**APPENDIX 4B**

**DETAILED DRAWINGS FOR THE 200 AREA EFFLUENT TREATMENT FACILITY  
CONTAINER STORAGE AREA AND TANK SYSTEMS**

1. ECN 647892

CHANGES/ADDITIONS ARE SHOWN IN CLOUDED AREA, MODIFY DRAWING AS SHOWN IN CLOUDED AREA.

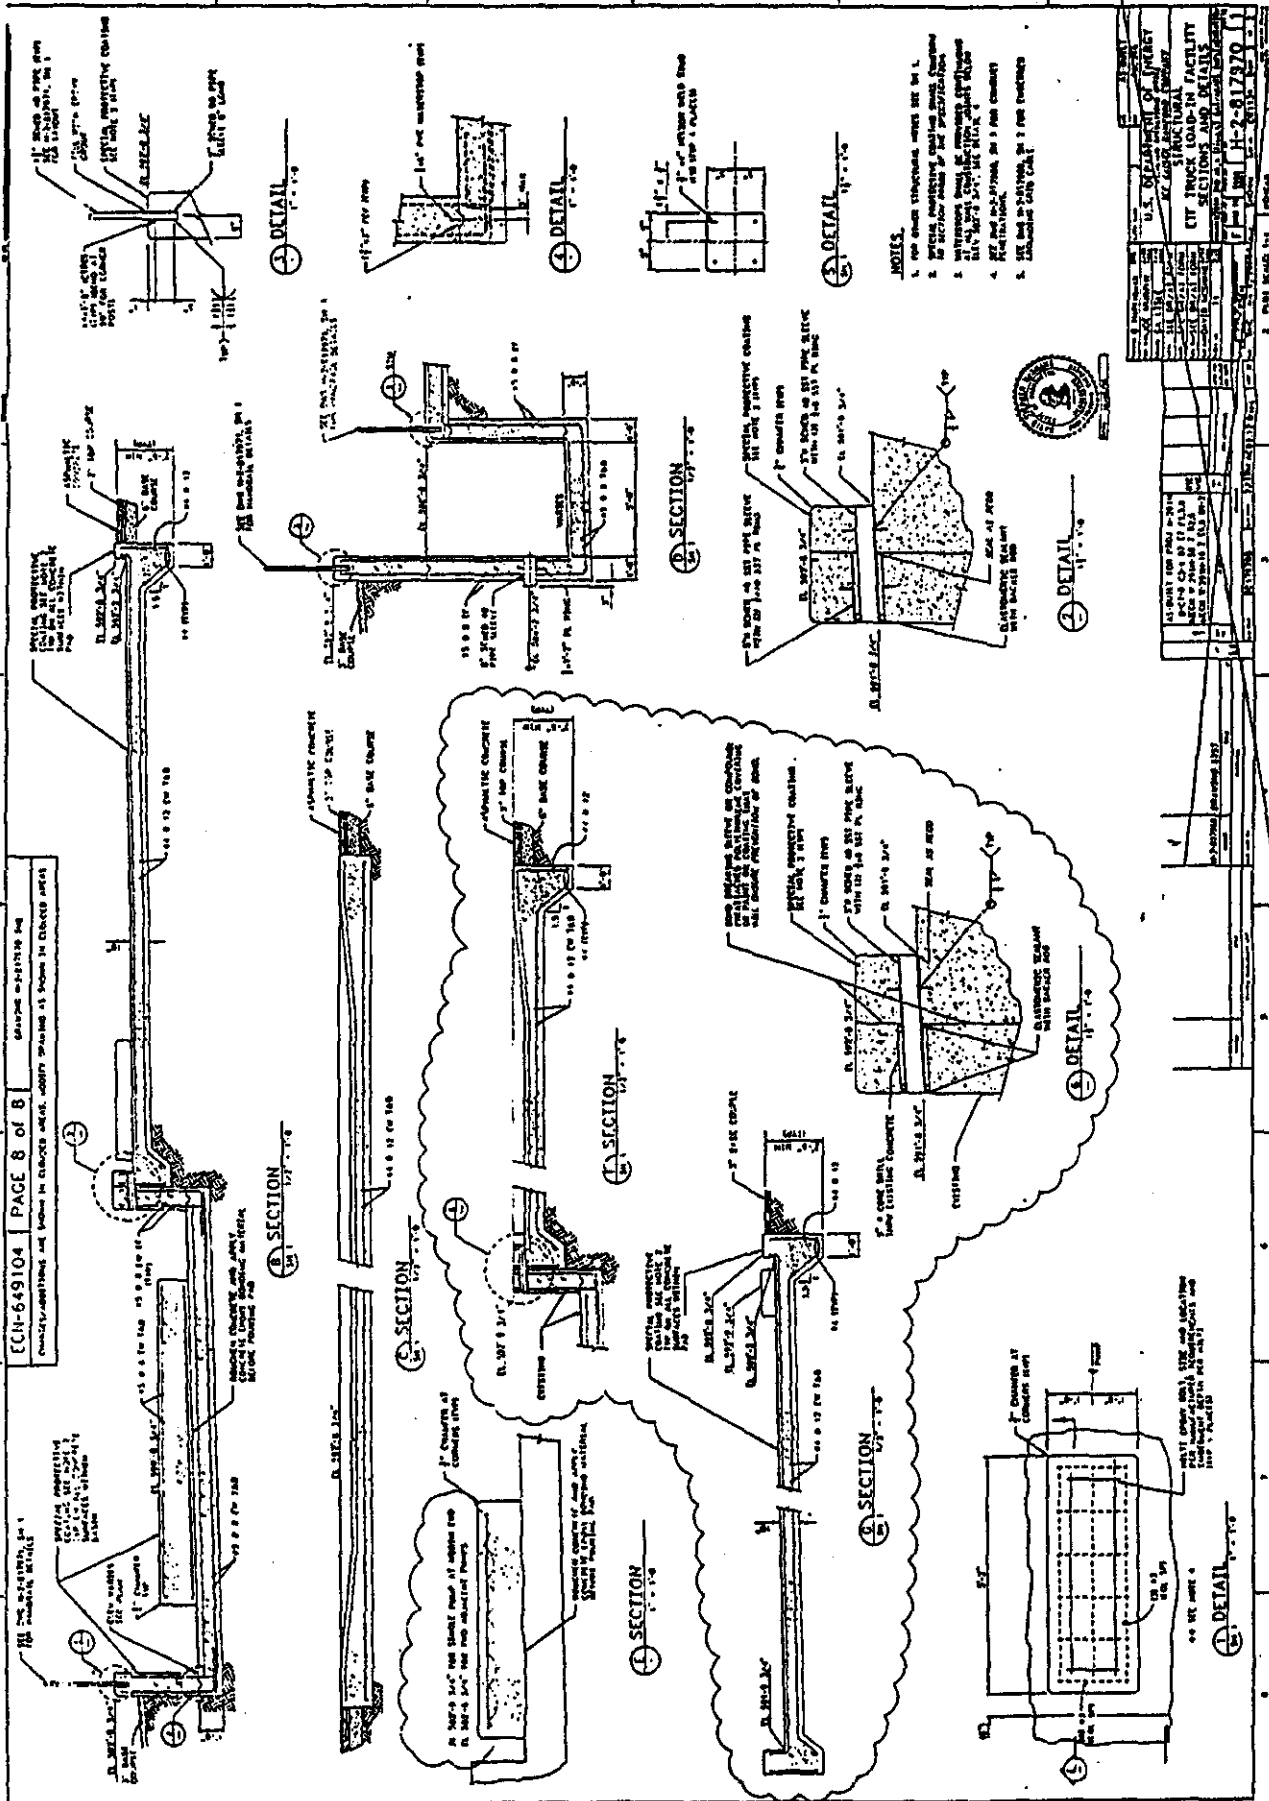
Zones C/F-5/8: Add asphalt and concrete pad areas, filter skid, pump base, dimensional details and Section G reference.

Zones A/D-4/8: Add Sections F and G and Detail 6. Add note to Section E identifying elevations of respective pump pads.

CHANGES/ADDITIONS ARE SHOWN IN CLOUDED AREA, MODIFY DRAWING AS SHOWN IN CLOUDED AREA..

Rev	Rev	Rev	Prepared By	Checked By	ECH No	Page
4-2-88766	3	6	CL UHLMAN	Mark Friederich	648.330	17

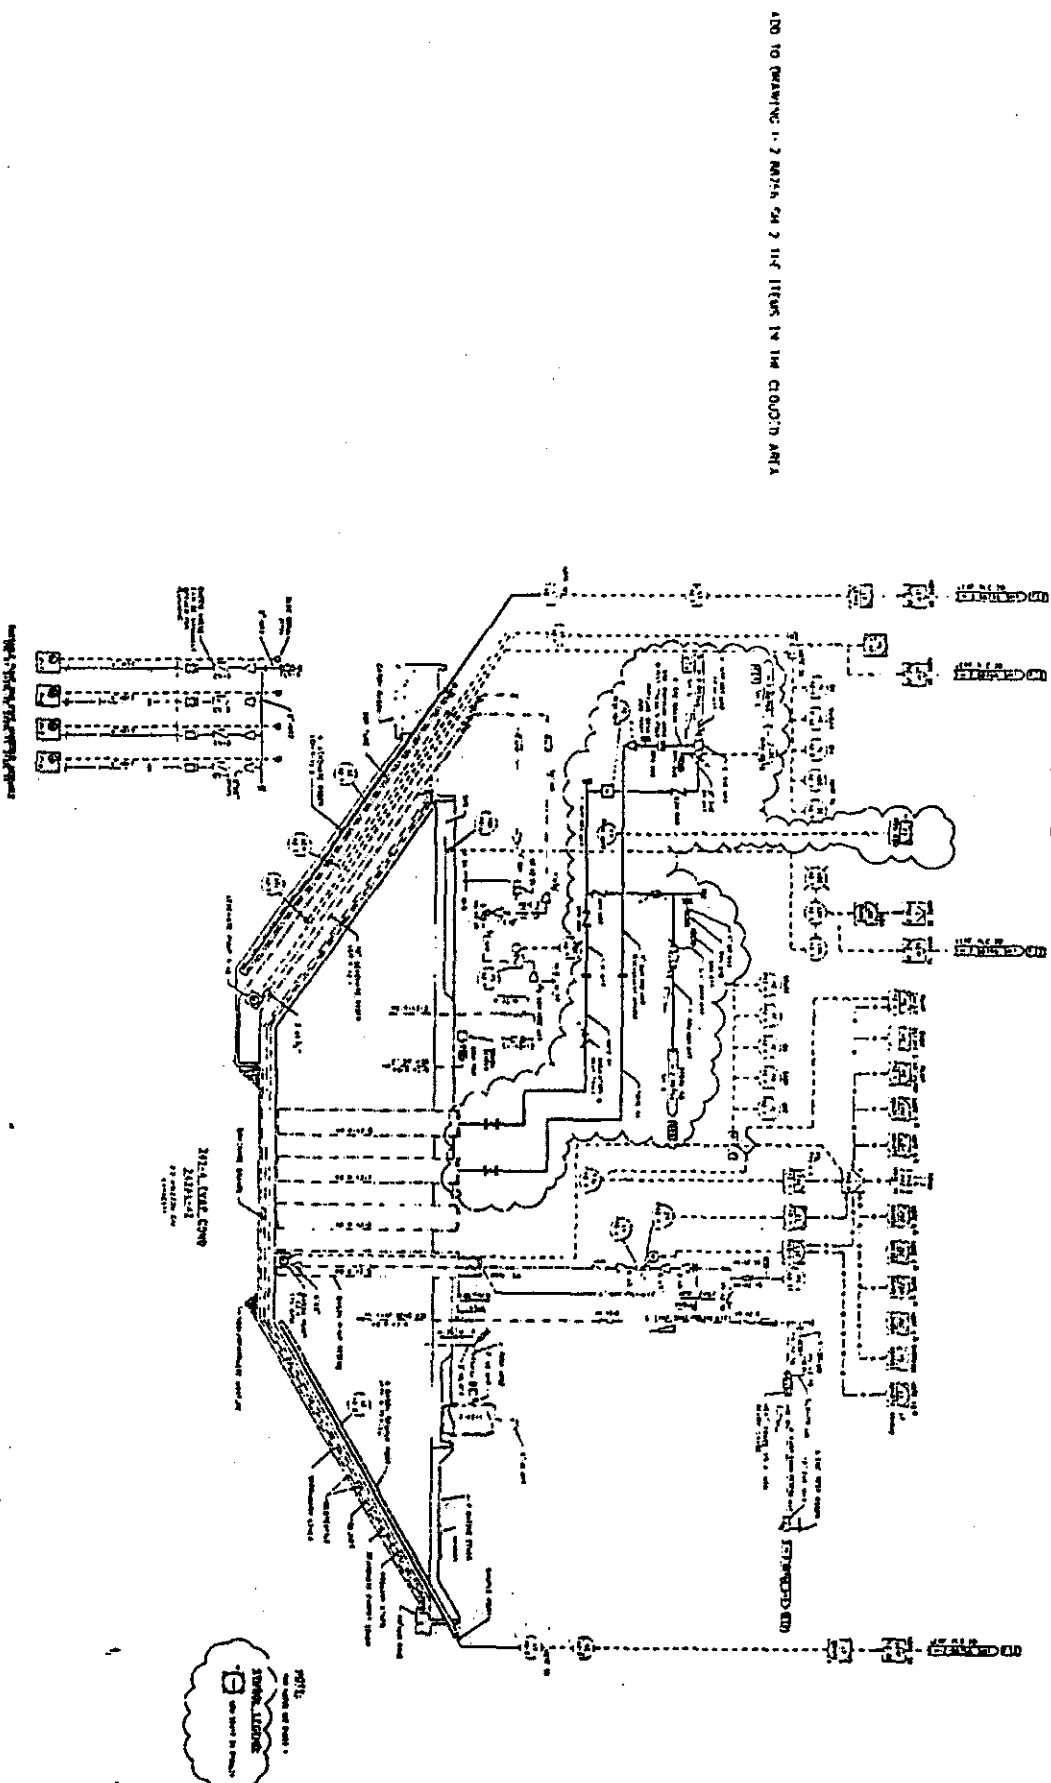
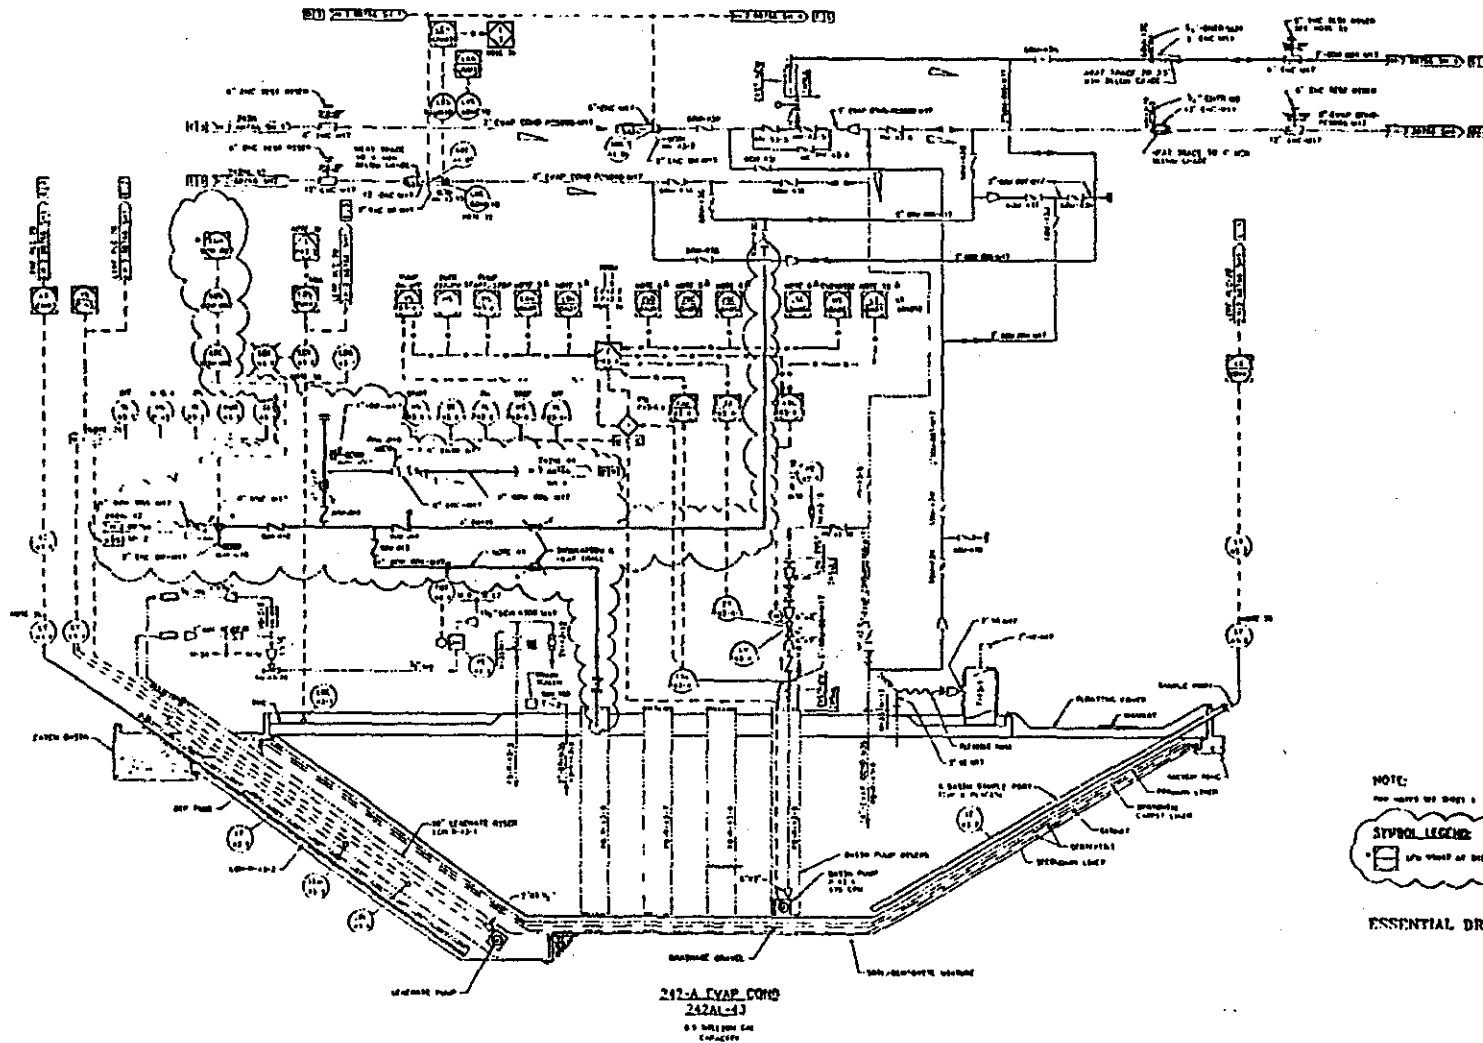
1. MODIFY M-2-88768 SHEET 1 AS SHOWN  
ON CIRCLED AREA
2. RENAME DRAWING TITLE.  
M&C 2020 - LEAF INTERFACE

ADD ITEMS IN CLOUDED AREA  
AS SHOWN

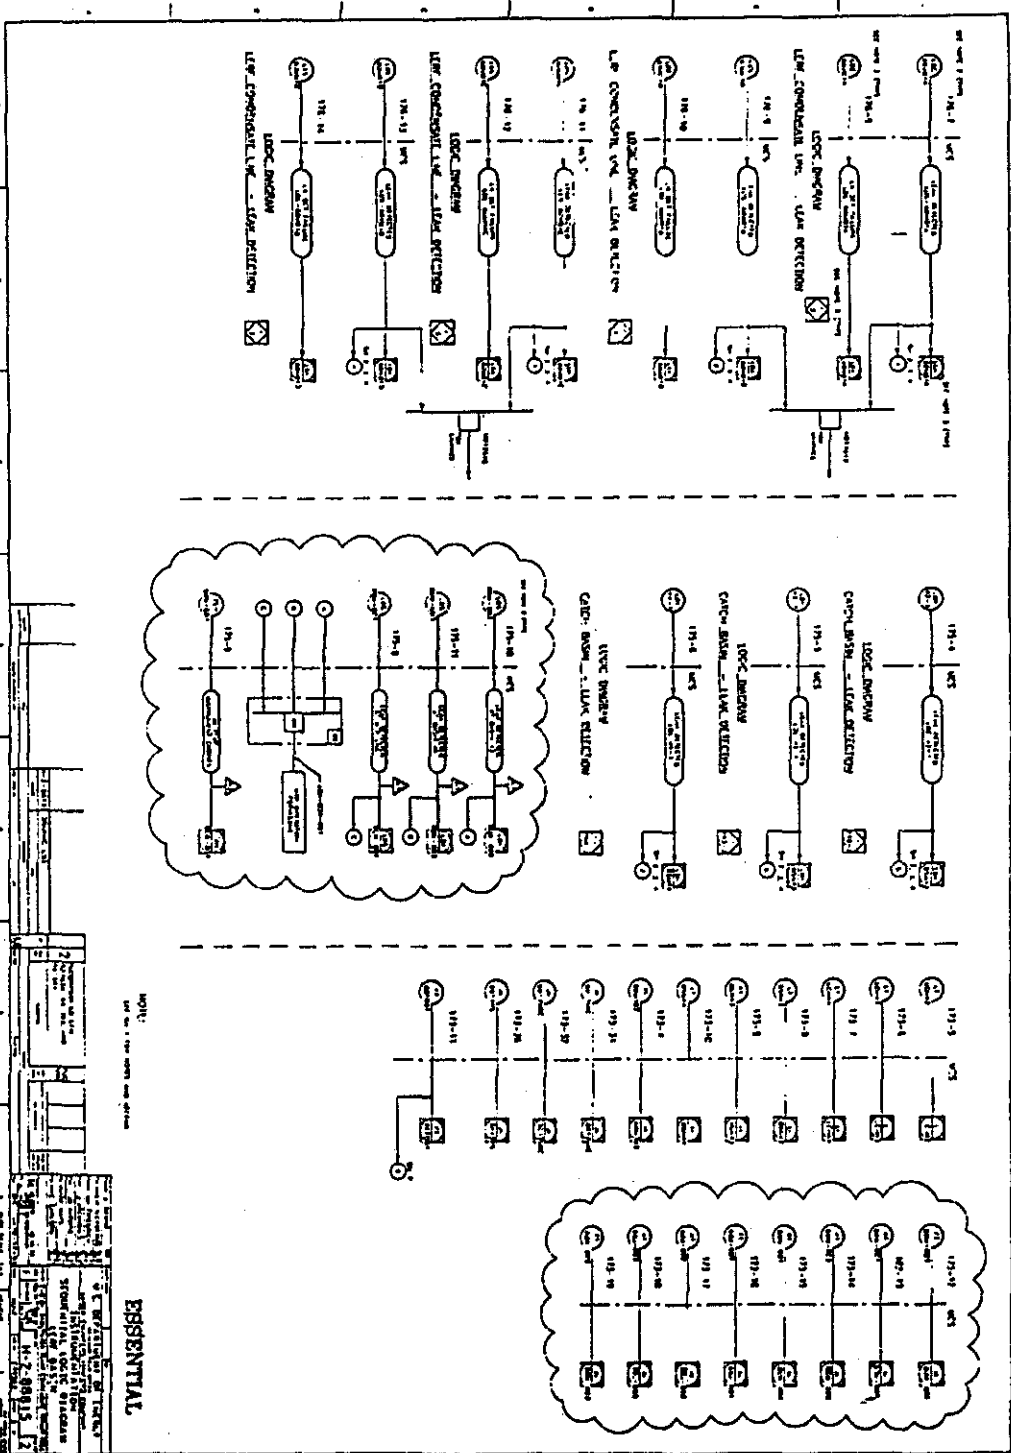
ADD CLOUDED AREAS TO  
--2-88815, (SHEET 5)

H-2-88976, Sheet 1, Rev. 6, Zones C6-F6

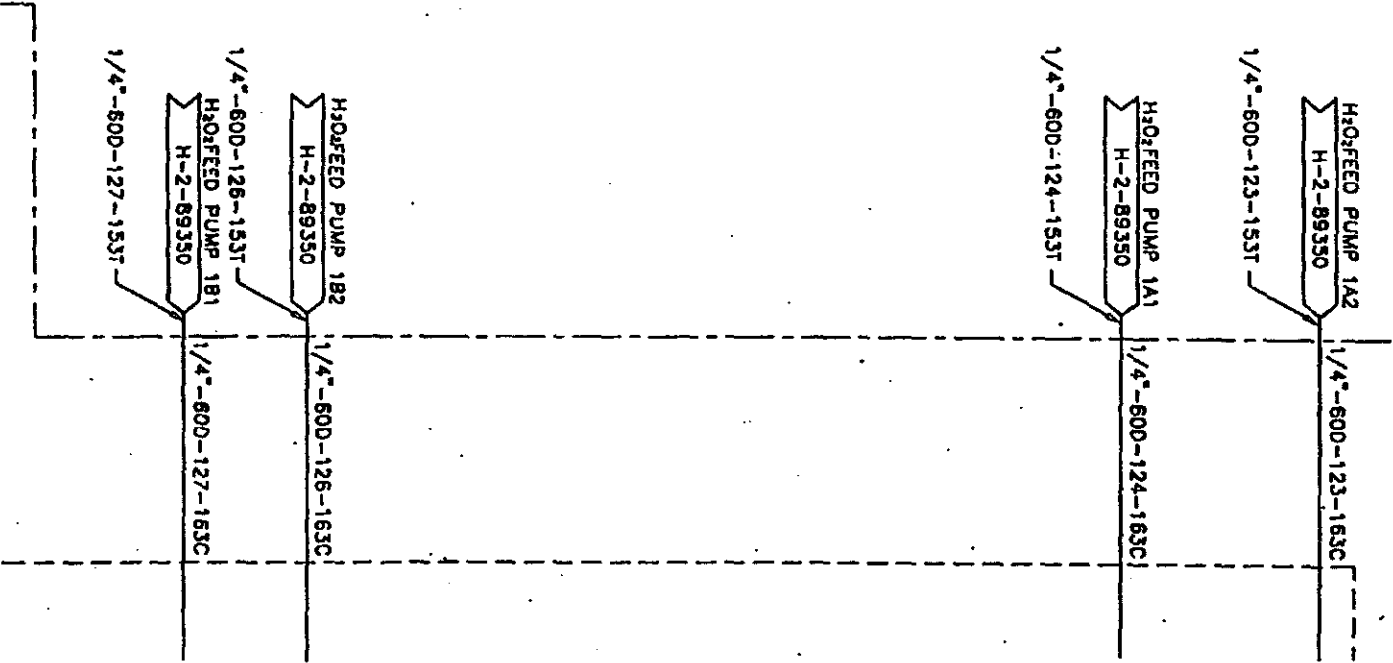
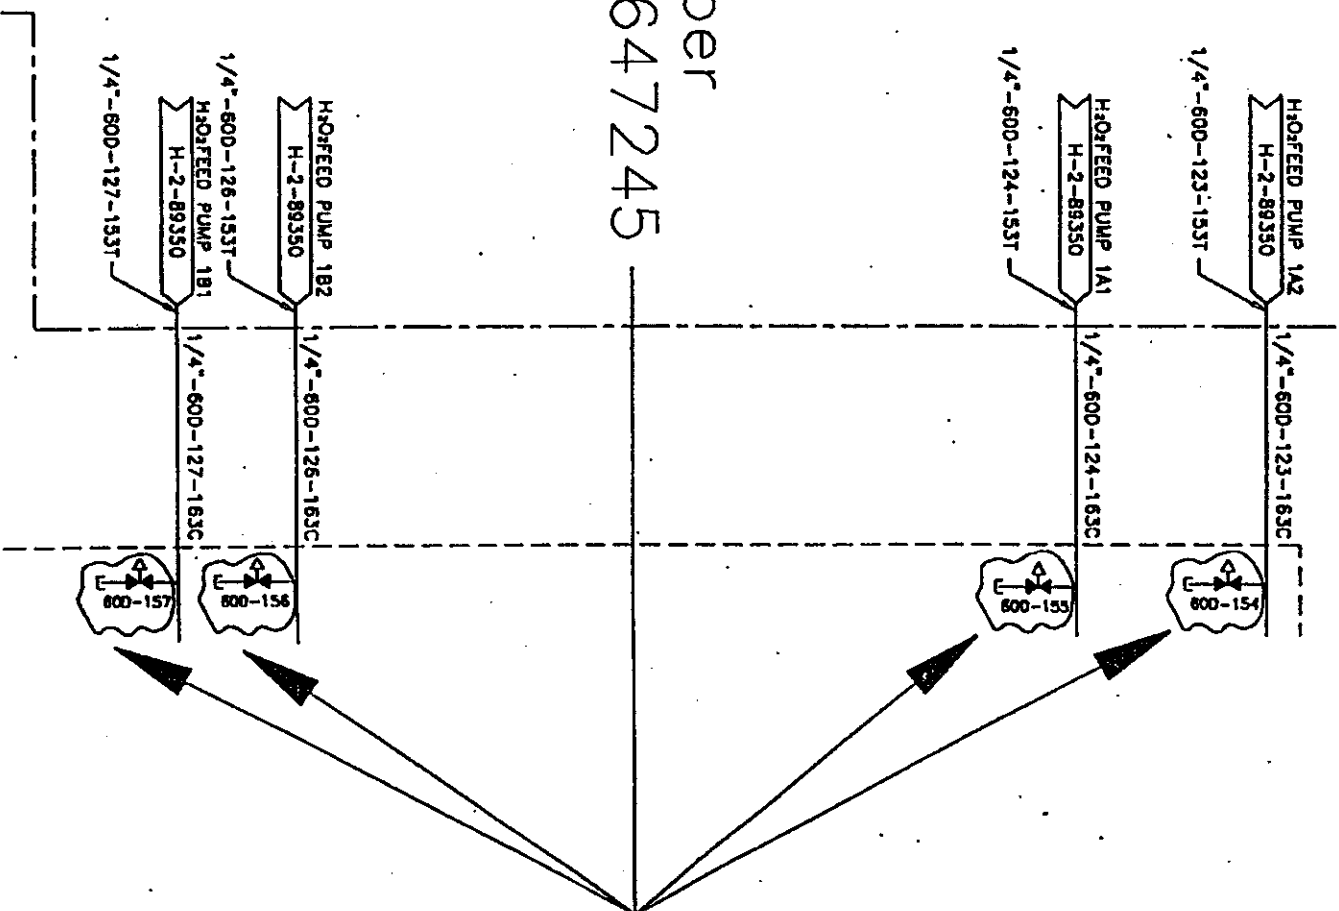
IS:

CHANGE TO:

H-2-89350, Sheet 1, Rev. 8, Zone B6

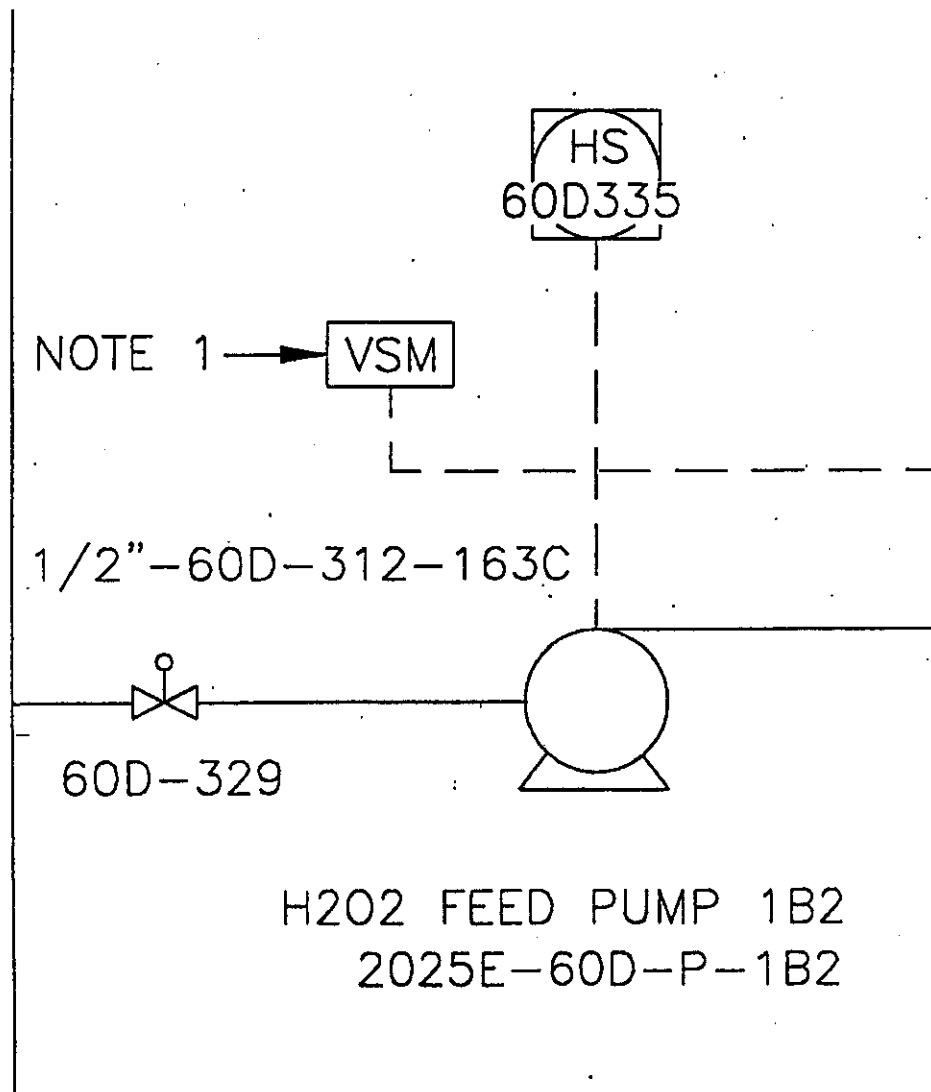
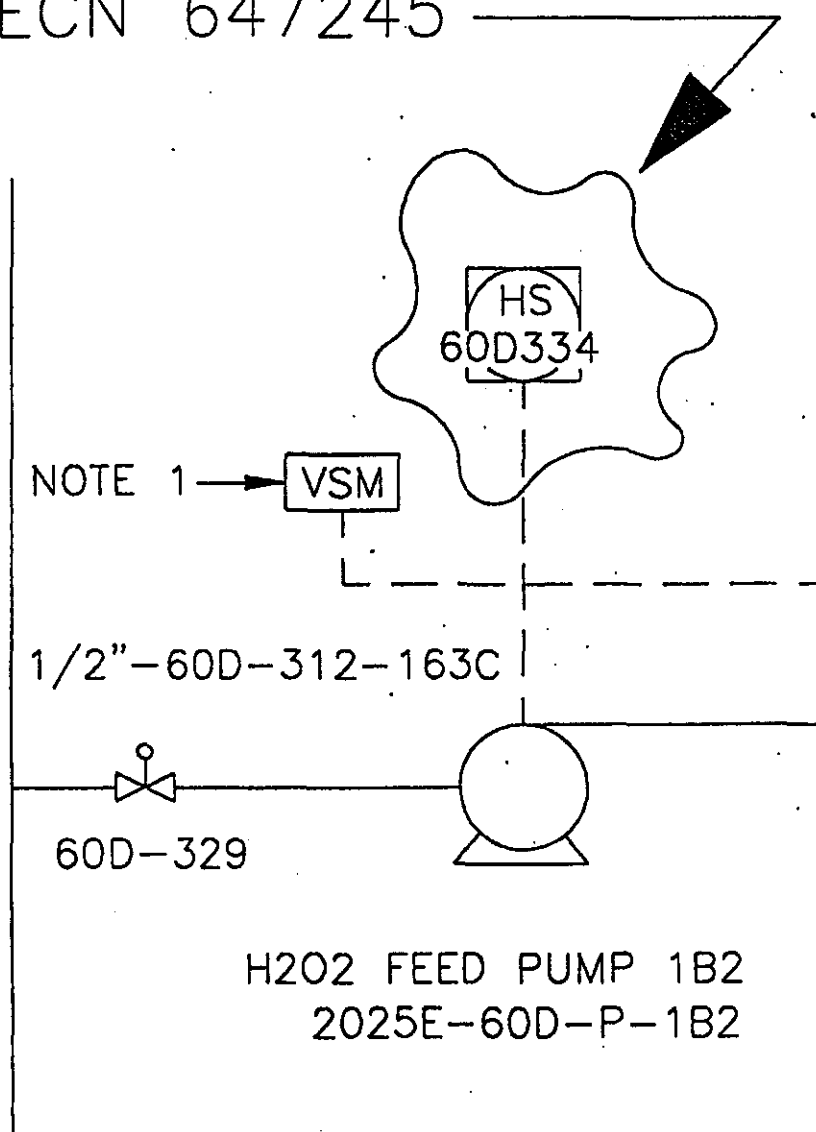
Change Hand Switch Number  
per ECN 647245
